BROWNS FERRY NUCLEAR PLANT (BFN) - UNITS 1, 2, AND 3 -  
TECHNICAL SPECIFICATIONS (TS) CHANGES TS-431 AND TS-418 -  
EXTENDED POWER UPRATE (EPU) - RESPONSE TO ROUND 10  
REQUEST FOR ADDITIONAL INFORMATION (RAI) (TAC NOS. MC3812,  
MC3743, AND MC3744)

TECHNICAL SPECIFICATIONS (TS) CHANGES TS-431 AND TS-418 -  
EXTENDED POWER UPRATE (EPU) -  
RESPONSE TO ROUND 10 REQUEST FOR ADDITIONAL INFORMATION (RAI)  
(TAC NOS. MC3812, MC3743, AND MC3744)  
RESPONSE TO ROUND 10 RAI QUESTIONS

Figure ACVB-70/68-1  
NPSH Requirements for DBA-LOCA - Short Term

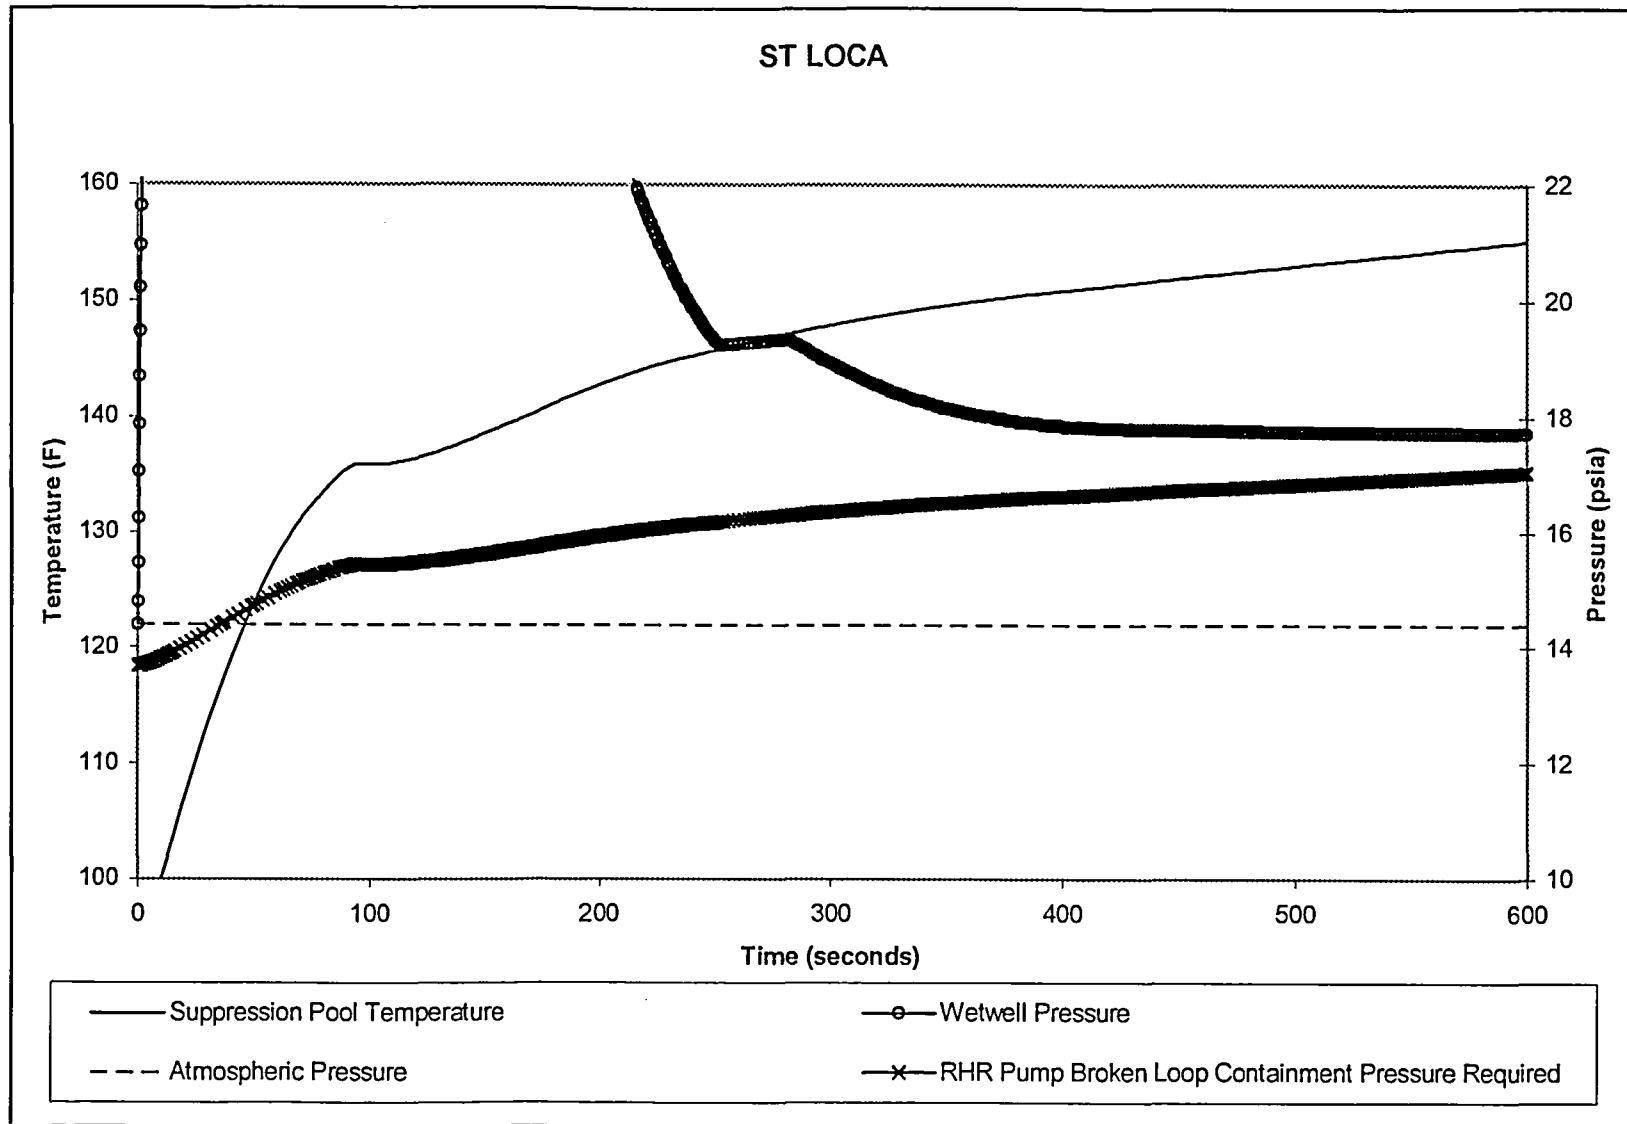
### NRC RAI ACVB-70/68

Verify that at 105% power, for the short-term LOCA, the available NPSH is always greater than the required NPSH at the peak RHR pump flow (11,500 gpm) without reliance on the testing reported in the May 24, 1976 report.

At 105% OLTP, the available suppression pool pressure for the RHR pumps that inject into the broken recirculation system discharge piping in the short term analysis would improve relative to 120% OLTP, but the lower power level alone would not result in a positive NPSH margin for the short-term case. This is determined by accounting for the difference in vapor pressure between peak suppression pool temperature short-term at 105% OLTP (see ACVB-69/67) and the same value at 120% OLTP (149.7°F versus 155.4°F). However, conservatism in the overall NPSH analysis is sufficient to offset the negative NPSH margin even at 120% OLTP and provides a high degree of confidence that the RHR pumps will be available after the initial broken loop operation. For example:

- 100% mixing of the broken loop flow with the drywell atmosphere is assumed, which results in under-prediction of drywell and suppression pool pressure during the short term analysis. This is conservative relative to the likely break geometries and limited distribution of cooler water throughout the drywell.
- Initial drywell relative humidity is assumed to be 100%, which limits the amount of non-condensable gas initially present in the drywell airspace. However, due to the design of the drywell and drywell cooling system, relative humidity is not expected to exceed 50%.
- NPSH required limits in the calculations are based on 11,500 gpm, whereas the calculated maximum flow for the broken loop of RHR is 11000 gpm. This results in a more restrictive NPSH required value.

An NPSH sensitivity analysis at 120% OLTP was performed assuming 50% relative humidity and 11000 gpm which shows that more realistic, but still conservative, values for these assumptions results in a positive NPSH margin for the broken loop case. Results are shown in Figure ACVB-70/68-1.
